UNITED STATES PATENT AND TRADEMARK OFFICE

| APPLICATION NO. | FILING DATE | FIRST NAMED INVENTOR | ATTORNEY DOCKET NO. | CONFIRMATION NO. |
|---|-------------|----------------------|----------------------------|------------------|
| 10/823,854 | 04/14/2004 | Paul Tashjian | PTJ-101US | 5501 |

| Office Action Summary | Application No. 10/823,854 | Applicant(s) TASHJIAN, PAUL | |

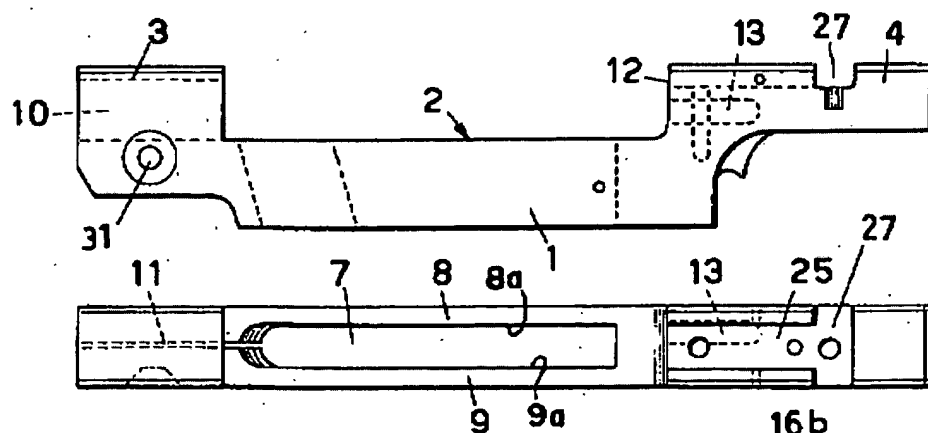
3. Claims 1, 2 and 5 are rejected under 35 U.S.C. 102(b) as being anticipated by US 3711980 issued to Palama. Palama discloses a receiver for a firearm as shown below.

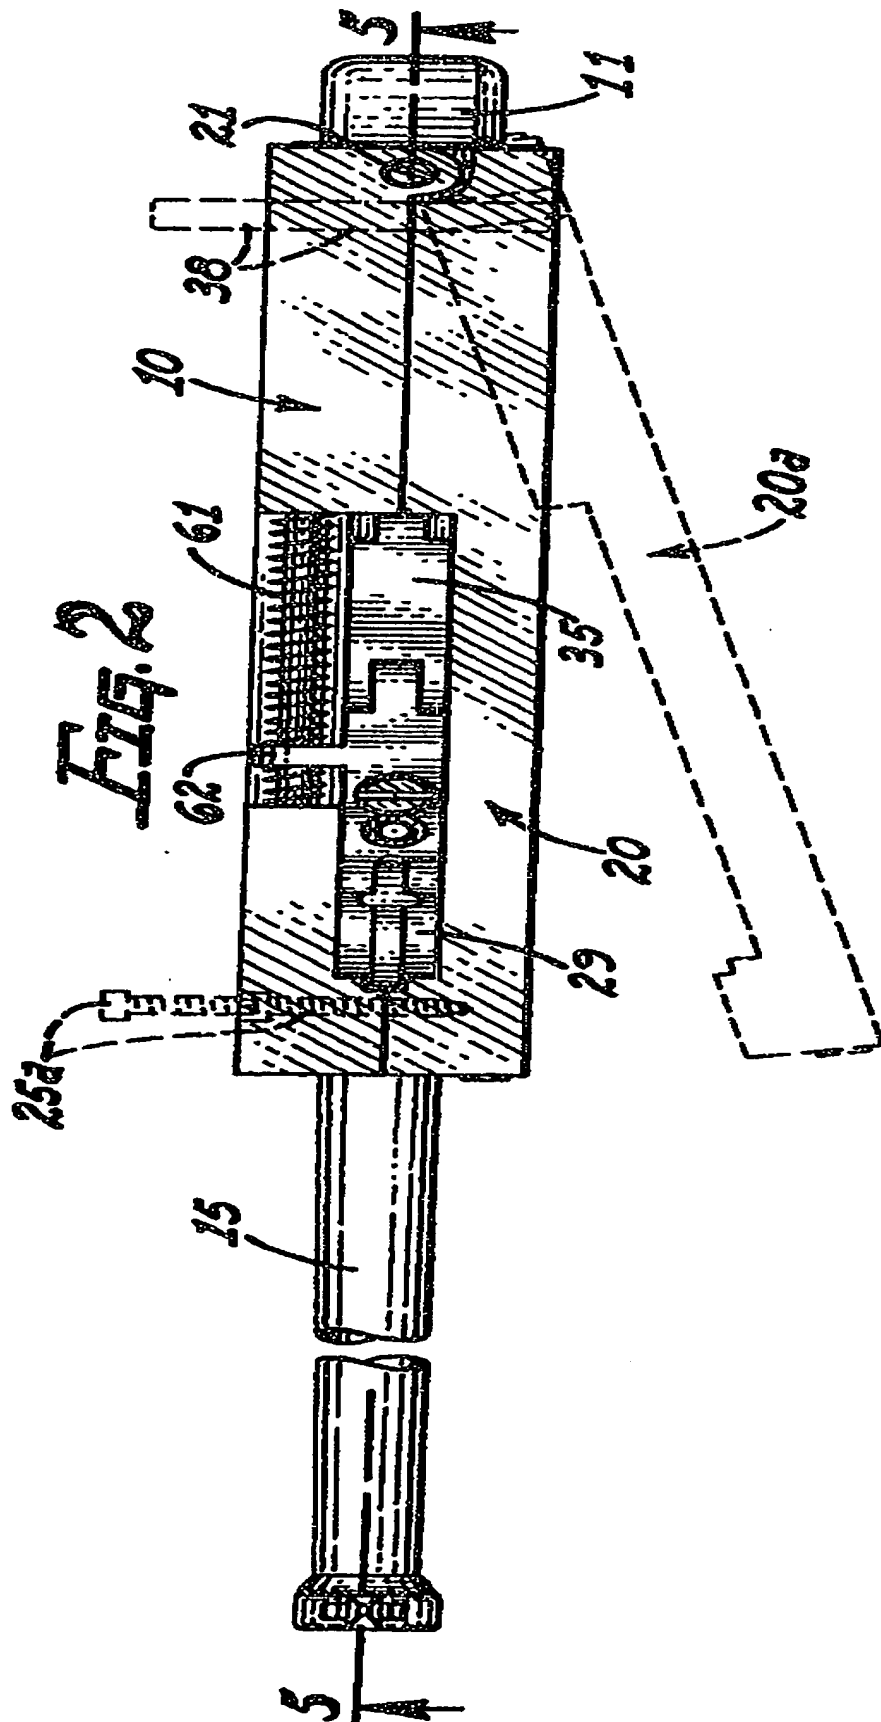
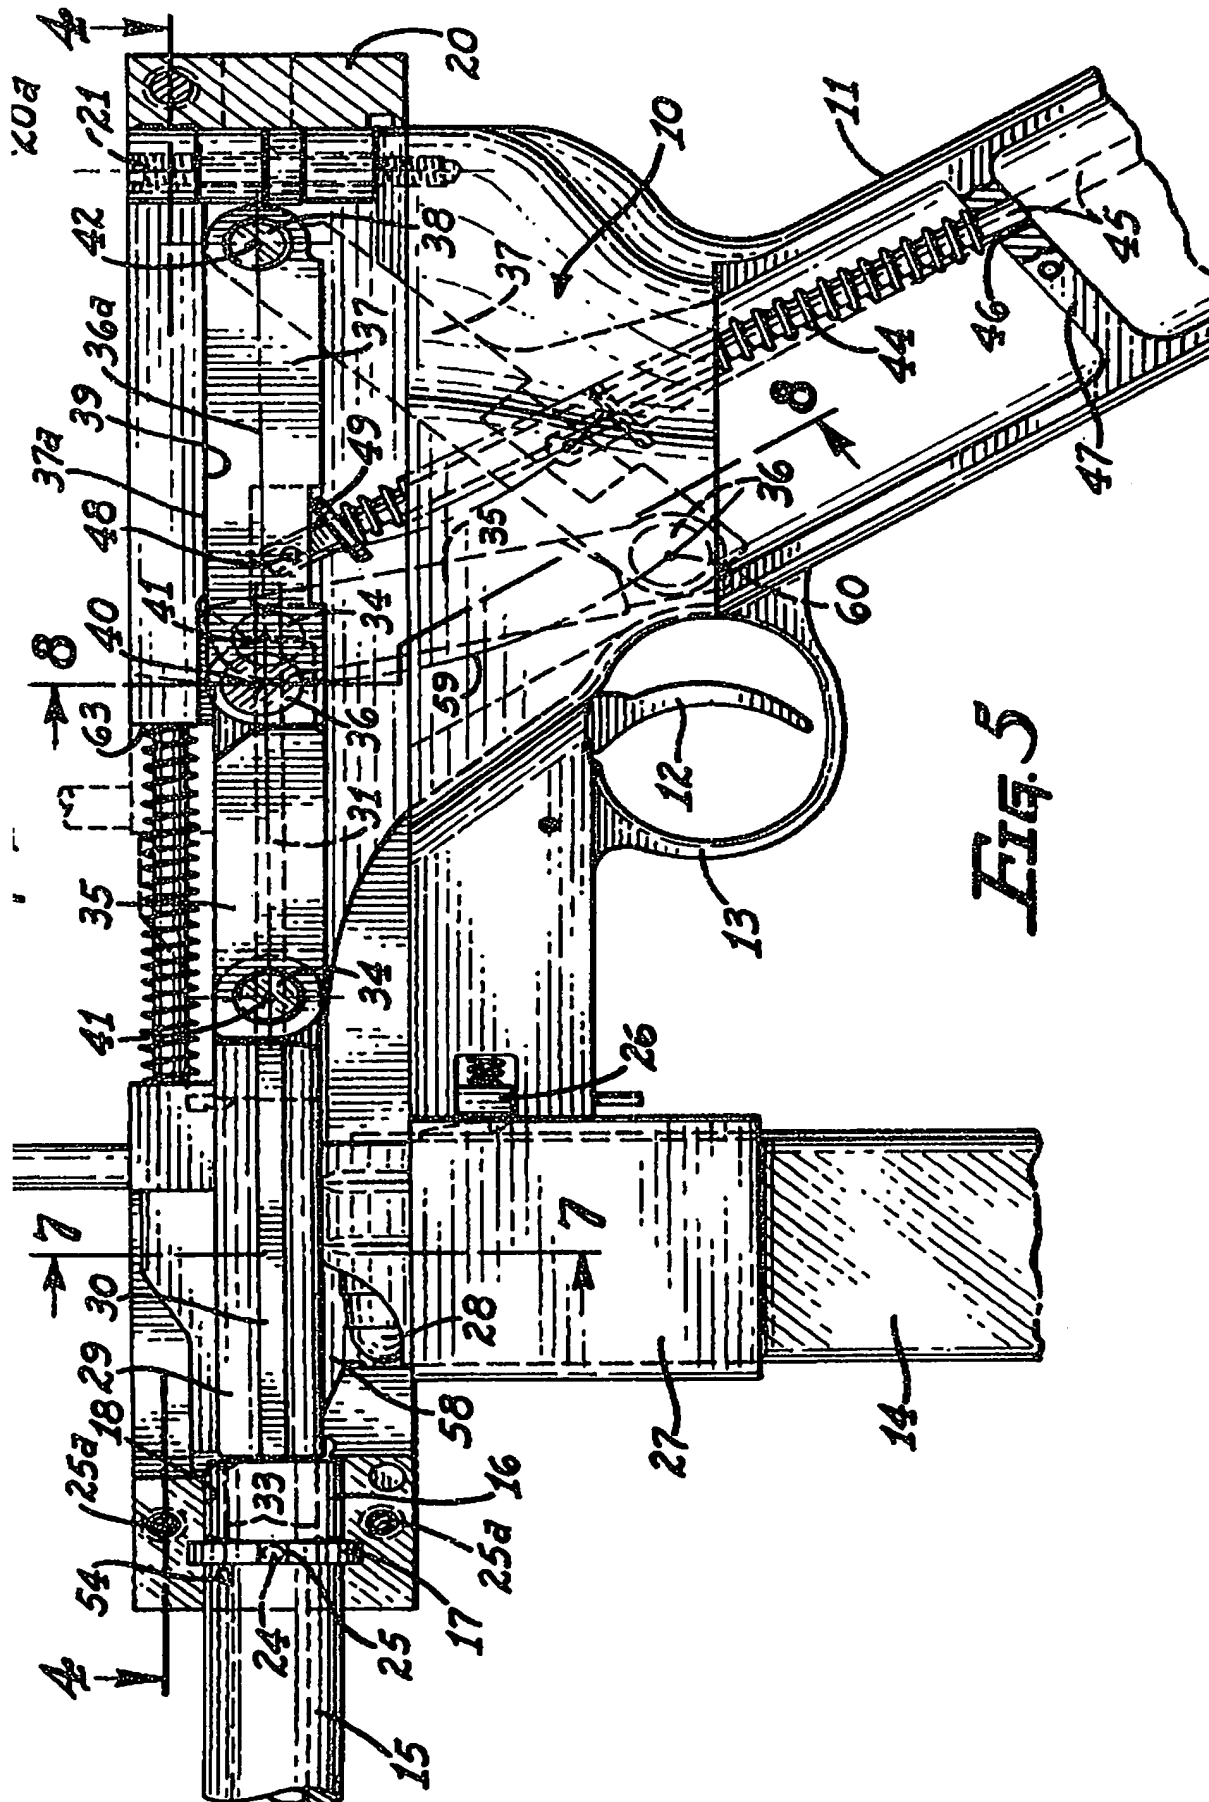
4. Claims 1, 2 and 5 are rejected under 35 U.S.C. 102(b) as being anticipated by Canadian Patent 925334 issued to Perrine. Perrine discloses a firearm as shown below.
